COMPANY / PROJECT
**ST185 CELICA GT-FOUR - LINK ECU CONVERSION**

TITLE
# LOGIC BOX - BASE

| PART / DWG NO. | REV | MATERIAL |
|---|---|---|
| **ST185-FB-105** | **S** | PA12 (SLS / MJF) |

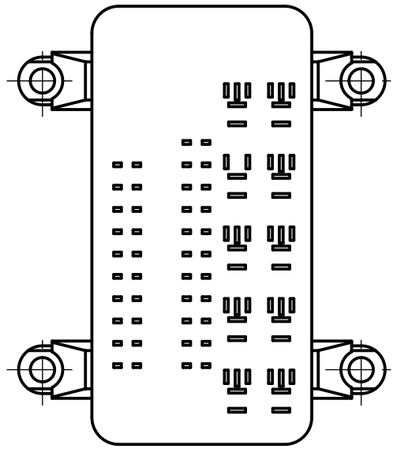
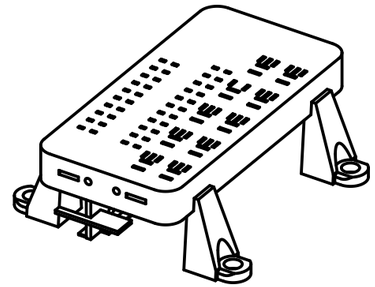
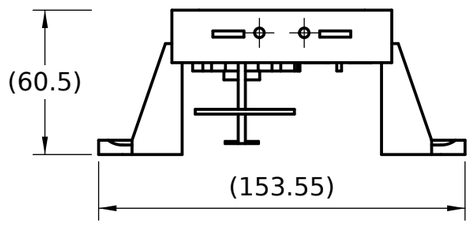
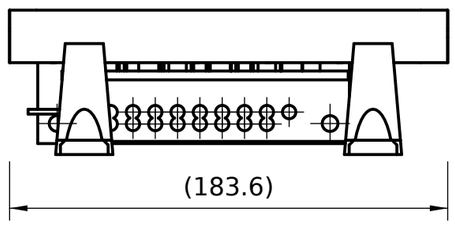
| REVISIONS | | | |
|---|---|---|---|
| K | R127 amendment: outer walls grown outward to 4.3, curved bend saddles back (#271) | Claude | 16/10/26 |
| M | Dan's N2 / N3 / N4 answers (#273) | Claude | 16/10/26 |
| N | LOGIC Bus 2 x 48.1 corner joint stays solid (sweep fixes) (#275); first drawing issued (#280) | Claude; drawing SteveCAD | 17/10/26 |
| P | Dan's markup 17/10/26 (23-21): spare fuse positions deleted, the rest on a 9.35 grid from y 31.7 (jumpers sized by fuse) | Claude | 18/10/26 |
| R | Fit audit + N21 18/10/26 (R165, R166): micro relay pattern to TE V23074, sockets 3.2 deep; mini fuse sockets at the real 8.1 pitch with TE MCP 2.8 receptacles; box 3.15 wider; spine 3.0 | Claude | 18/10/26 |
| S | HEAD relays M1 / M2 get the 87a blade slot (R170, #308): model changed after the R drawing; drawing reissued in the buildability review 18/10/26 | Claude | 18/10/26 |
